**TOWN OF COVENTRY, RI
DEPARTMENT OF PLANNING & DEVELOPMENT**

STAFF REPORT

Project Name:	395 Knotty Oak Road Rehab + Extension
Plan Type:	Minor Land Development / Use Variance
Plan Review Phase:	Pre-Application
Owner/Applicant:	John W. Studley III
Address:	395 Knotty Oak Road
Plat / Lot / Zone:	AP 70 Lot 104 Zone R-20 Lot Size 0.74 acres
Existing Use:	Commercial
Proposed Use:	Commercial
Description:	Applicant proposes to construct a 3,600 SF addition, of which 2,500 SF would be a replacement of a fire damaged section of the building and 1,100 SF of the building would be new construction of additional space. The existing use is a pre-existing non-conforming use, therefore the additional space would represent an expansion of the non-conforming use, and would require a Use Variance.

TECHNICAL REVIEW COMMITTEE REPORT

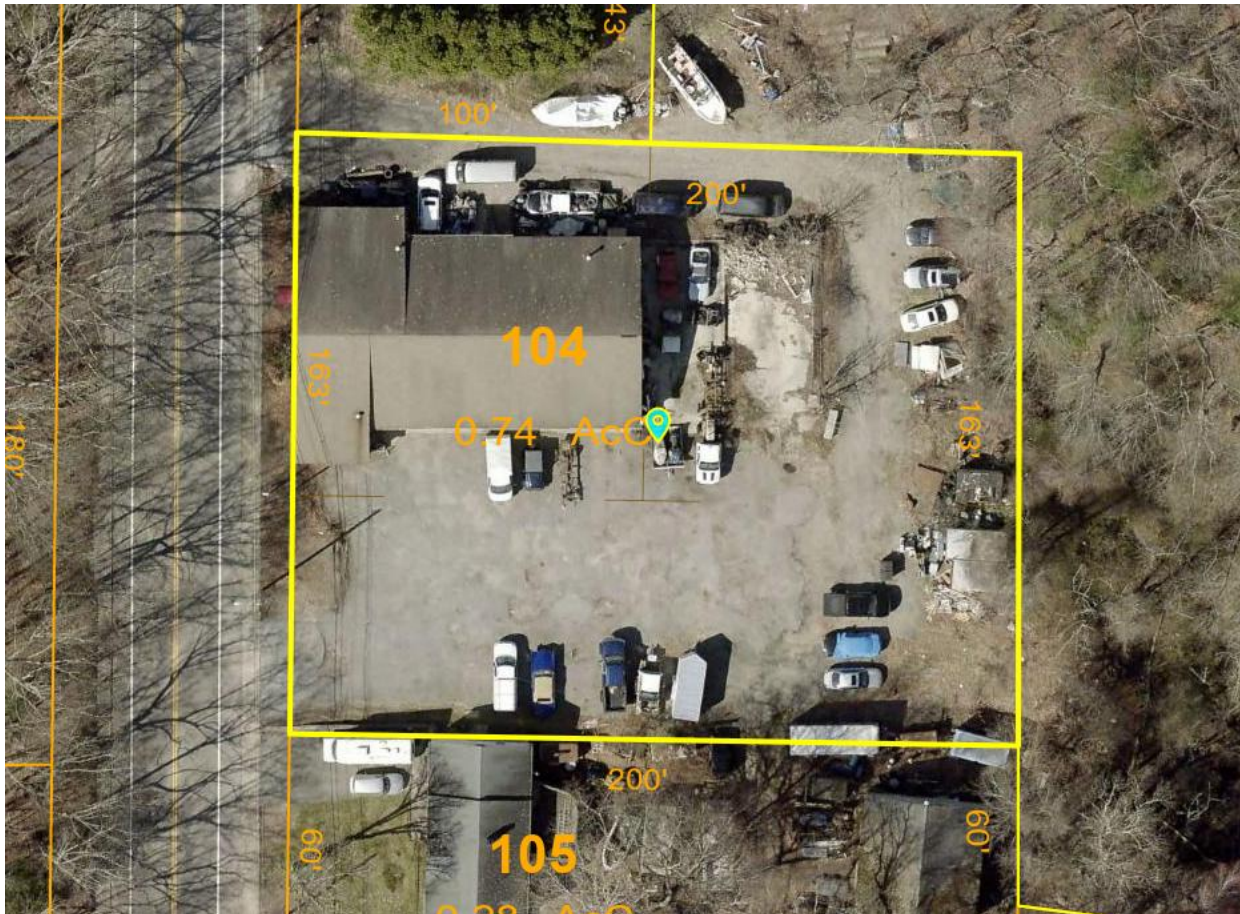
The applicant has proposed to build a 3,600 square foot addition to the rear (east) of the existing structure. 2,500 square feet of the new construction would be a rebuild of the portion of the building that burned down. An additional 1,100 square feet of the proposed addition would extend south and east from the portion of the proposed building that would be a rebuild, shown in red, below.
